**University of South Carolina Innovation Center Park**  
**Project Number: H27-Z263**  
**Project Manager: Emily Jones**

**Addendum Number Three (3)**

DATE: April 20, 2016

**D1.01**

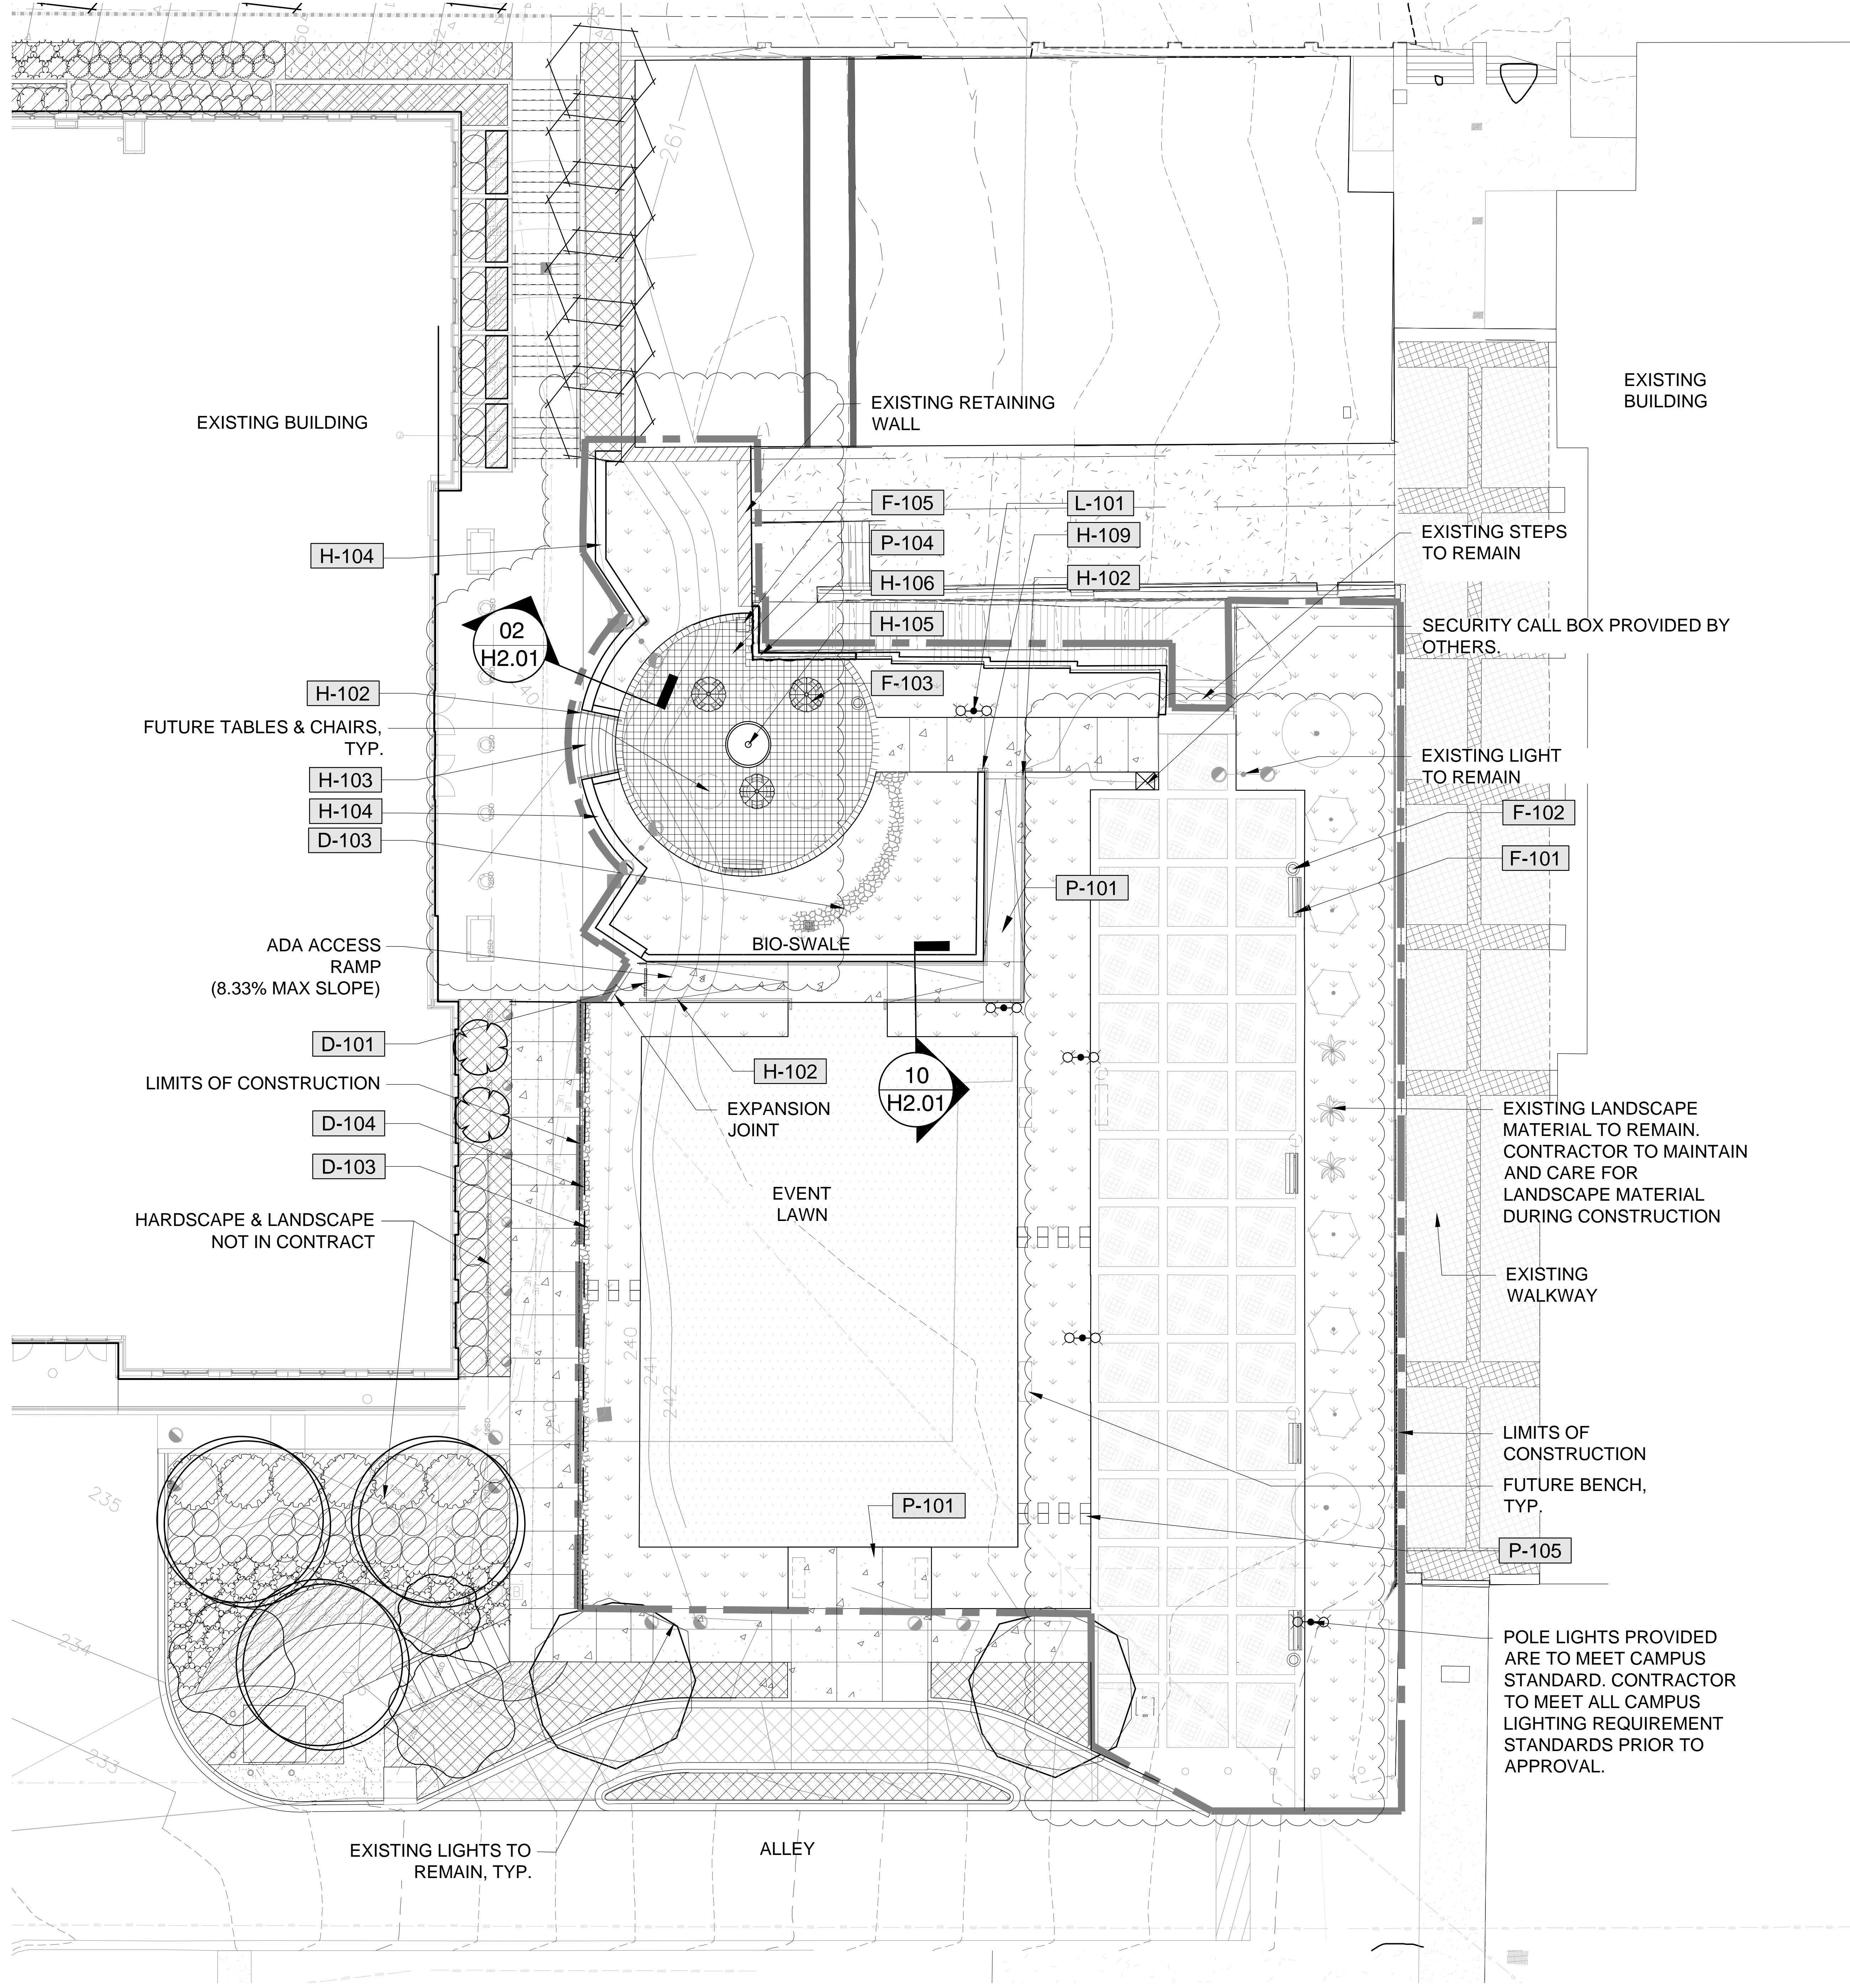
1. Bidders are advised that the current site condition has changed since the pre-bid meeting on March 30. The current site condition is highly compacted native soil with 1.5" depth of pine bark mulch. The Contractor may re-use the pine bark mulch for planting beds. Compacted soils shall be tilled and mixed with topsoil to a depth of 18" prior to installation of all landscape material.

12. CURRENT SITE CONDITION IS COMPACTED NATIVE SOIL WITH 1.5" DEPTH OF PINE BARK MULCH. CONTRACTOR MAY REUSE THE PINE BARK MULCH FOR PLANTING BEDS. IF THE MULCH IS TO BE REUSED, THE CONTRACTOR WILL BE RESPONSIBLE TO STORE THE MULCH AT THE DIRECTION OF THE OWNER AND LANDSCAPE ARCHITECT. COMPACTED SOIL TO BE TILLED AND MIXED WITH TOPSOIL TO A DEPTH OF 18" PRIOR TO THE INSTALLATION OF ALL LANDSCAPE MATERIAL.
